# APPROVED MINUTES

**September 16, 2010 Standards Committee Meeting**

RE: Minutes for the September 16, 2010 Standards Committee Meeting

**DETAIL A**

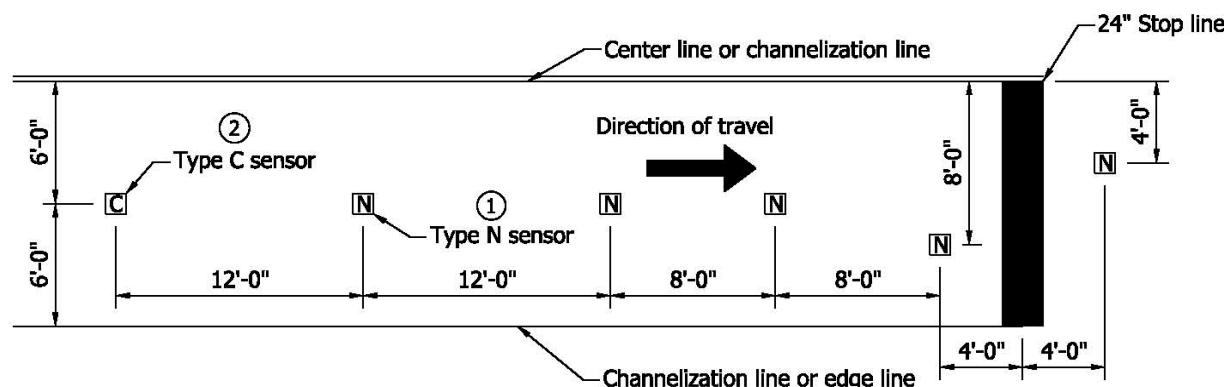
- ① Type N sensors detect only vehicle presence.
- ② Type C sensors detect vehicle presence and provide vehicle counts.
3. There should be at least  $\frac{1}{4}$ " and no more than  $\frac{1}{2}$ " of clearance between the top of the sensor and the top of the pavement

IDM 77-4.0 TRAFFIC SIGNAL EQUIPMENT

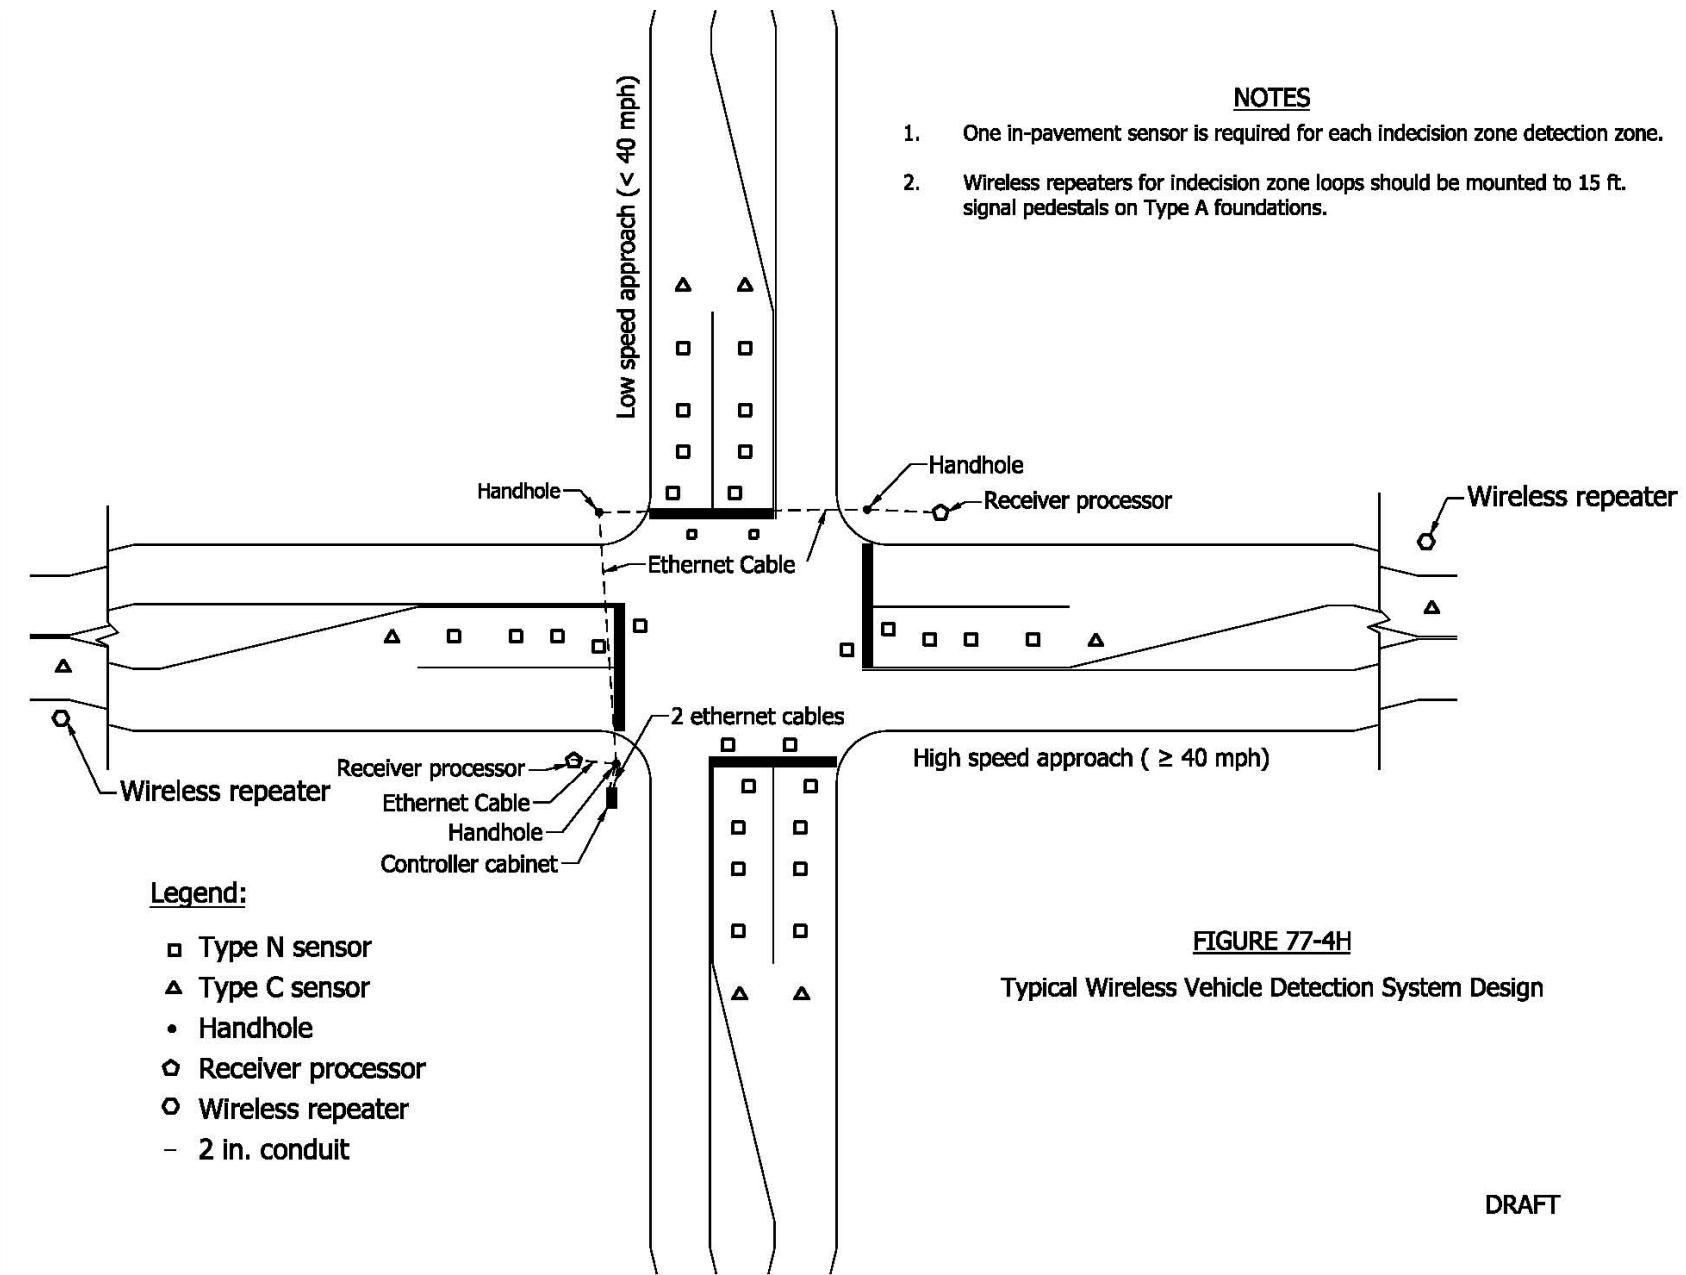
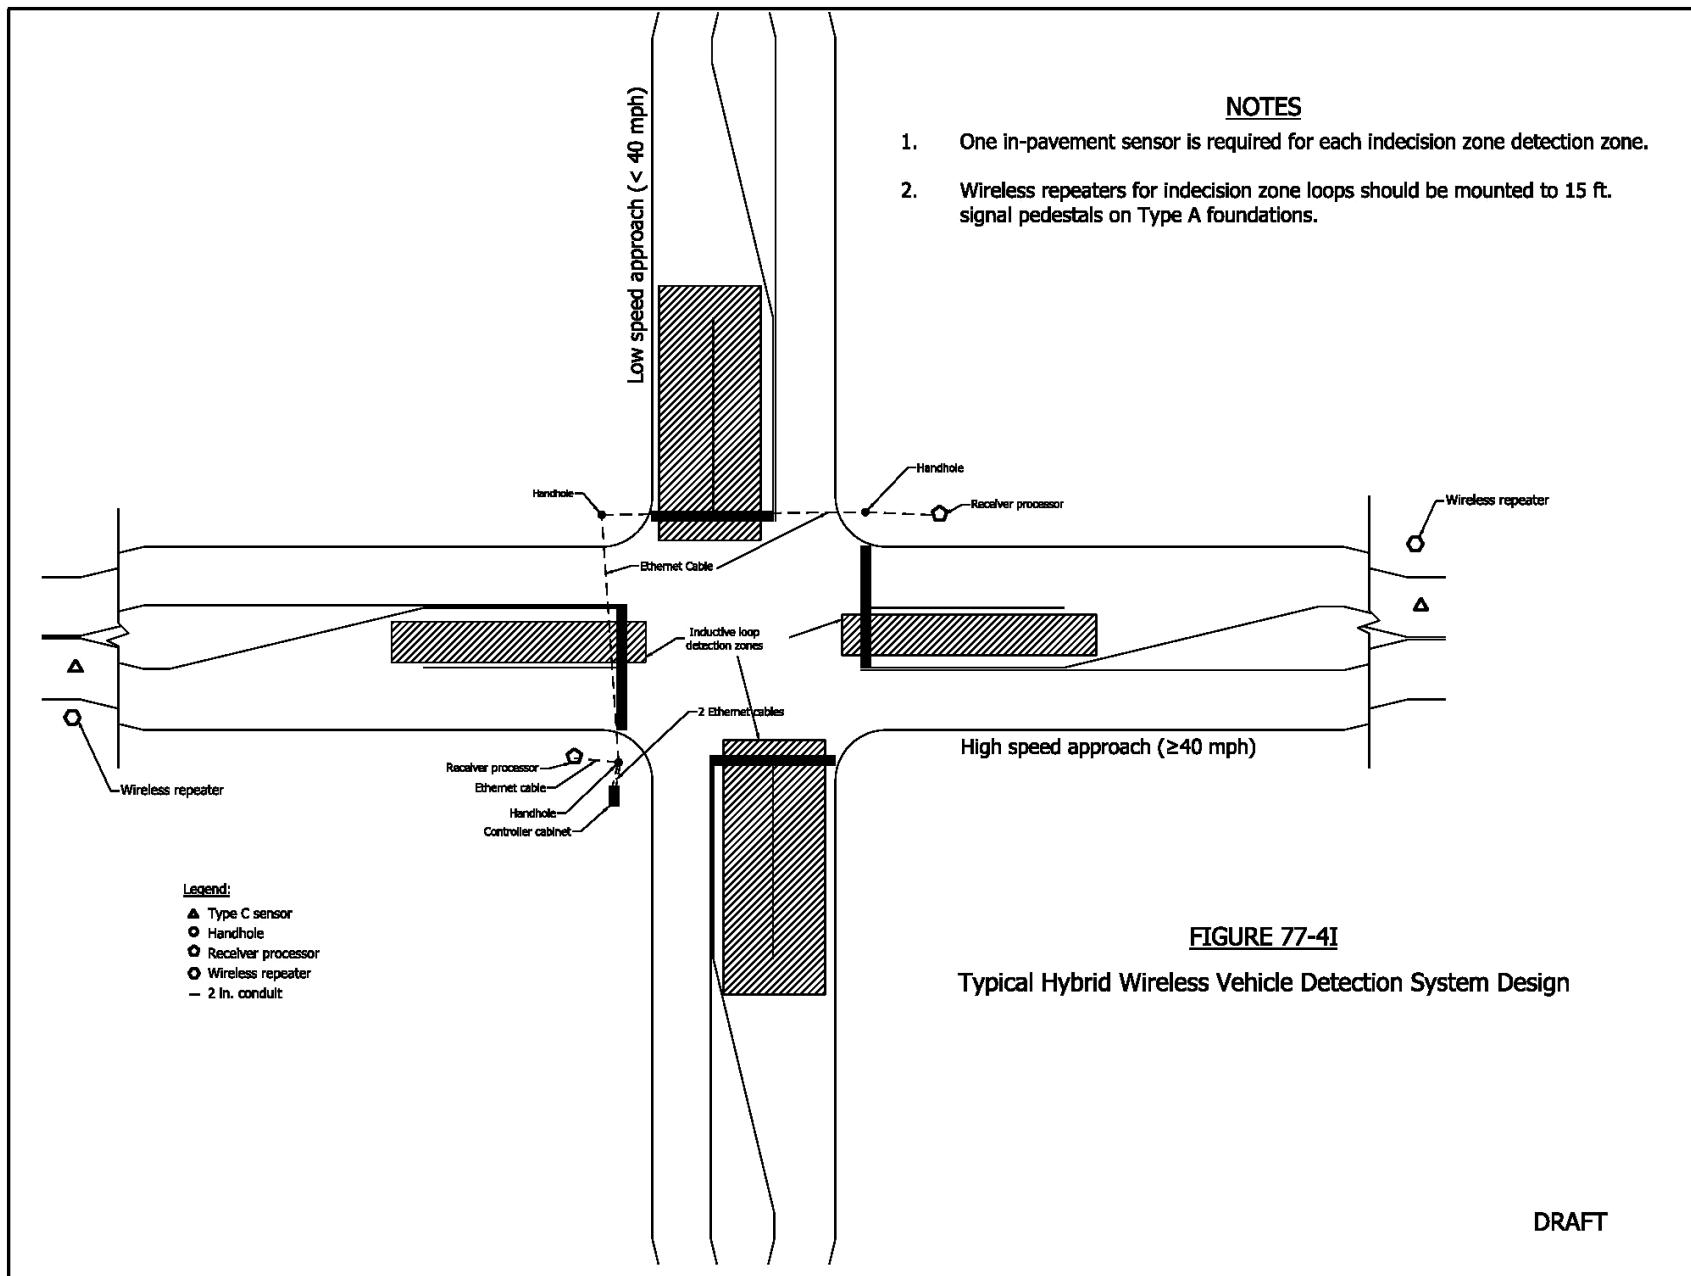
REVISION TO IDM 77-4.02(03) OTHER DETECTOR TYPES

ADDITION IDM 77-4.02(04) *DECISION MAKING CRITERIA FOR WHEN TO USE ANOTHER TYPE OF DETECTION*

*Detection systems other than inductive loops require a specialized design. In order to use a type of detection other than inductive loops, INDOT designers and consultants and local agency consultants must provide and submit documentation that 2 of the following 3 conditions have been met:*

REVISION TO THE STANDARD DRAWINGS

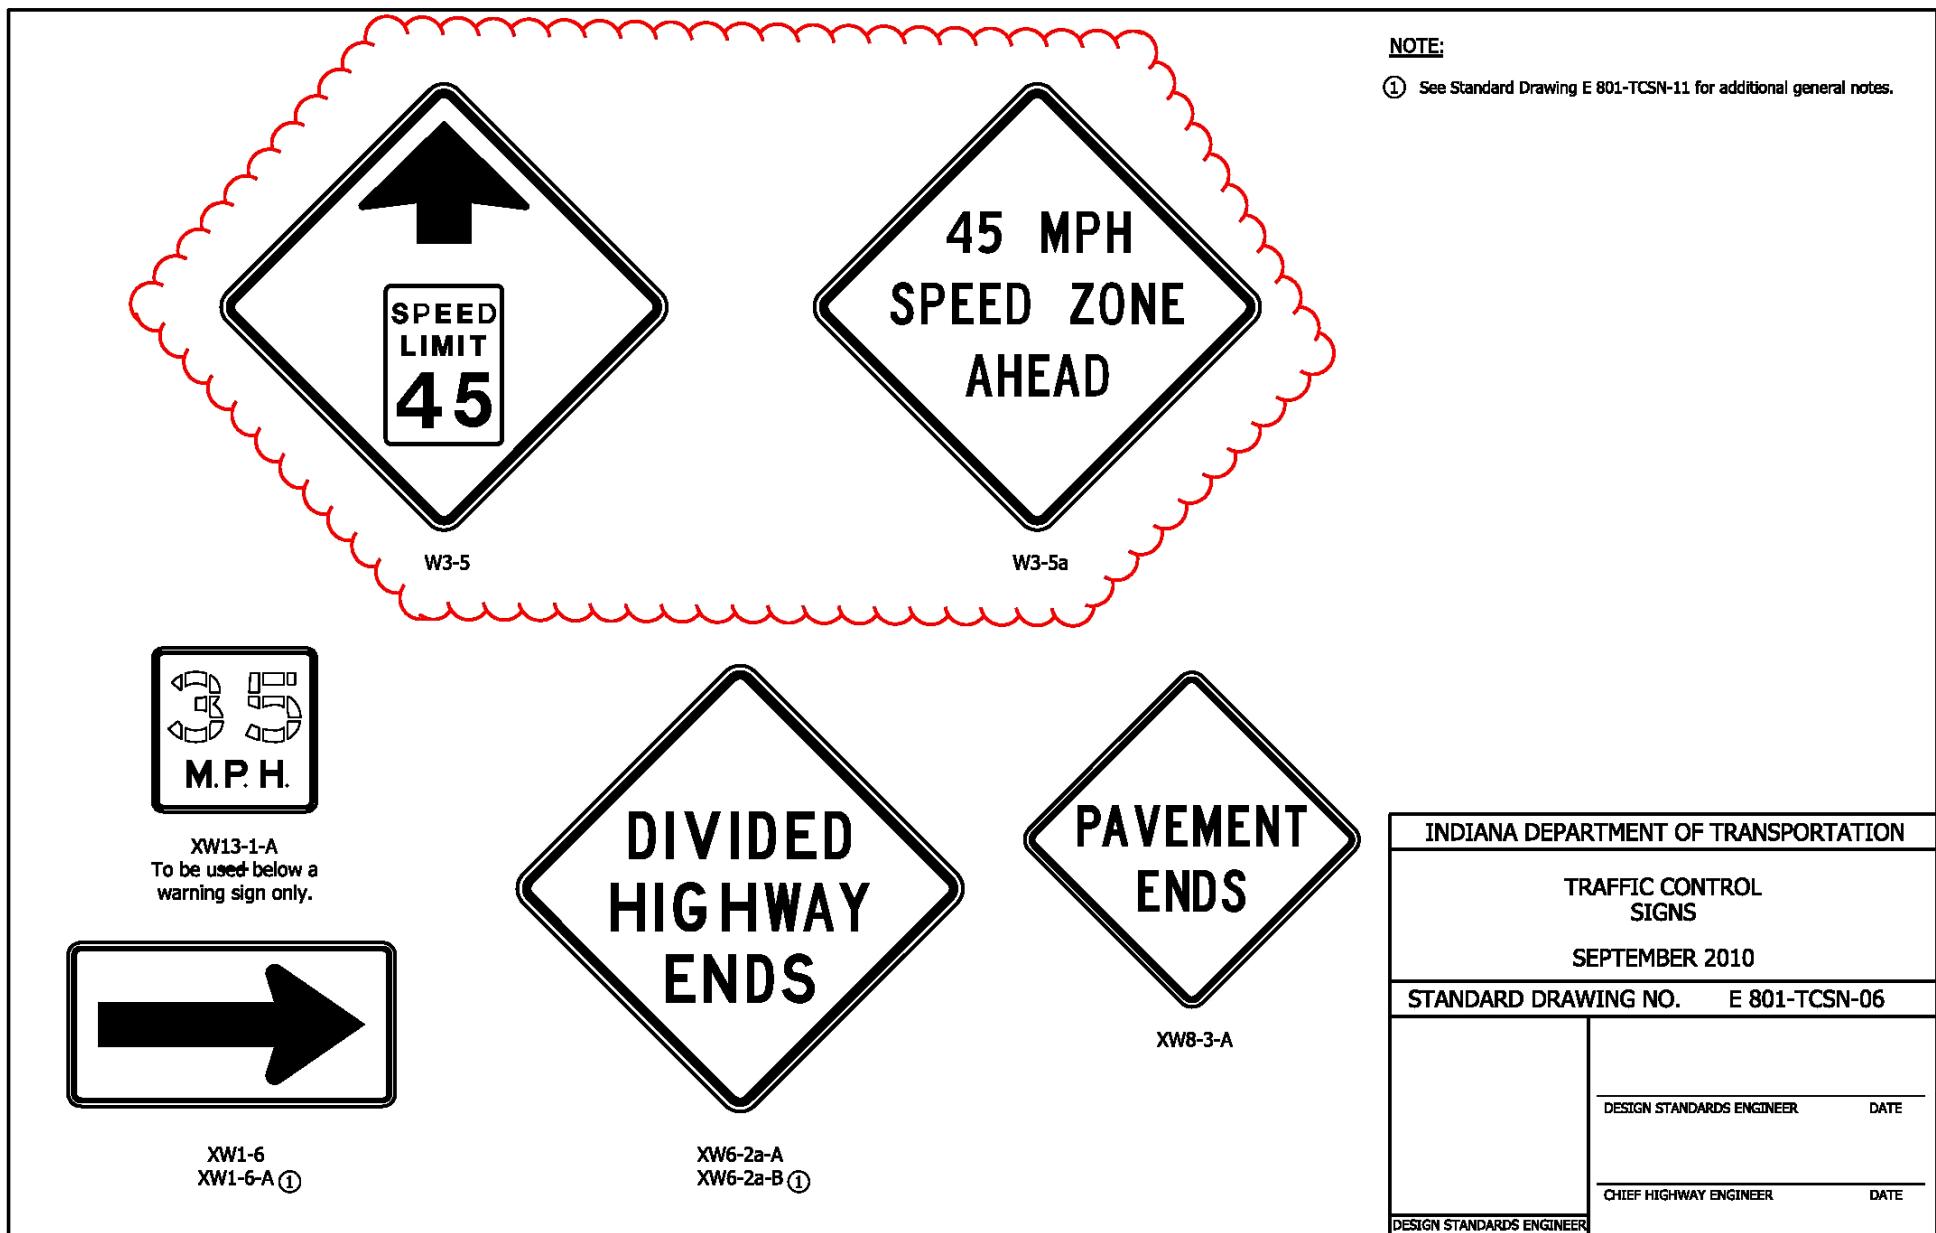
Mr. Uremovich asked if the speed limit is always going to be 45? Mr. Boruff said that it would not, so Mr. Uremovich suggested that the number 45 on the drawing be shown as a broken line like the 35 MPH sign below it. Mr. Caplinger asked if they'll have to go out and change all the signs. Mr. Miller commented that we have until 2018, and asked if we have until then? Mr. Pankow added that most people aren't using them anyway.

The motion then passed as revised and it was agreed to get this out in March 2011, with a sunset date of September 2011. Mr. Cales mentioned that recurring detail sheets are needed.
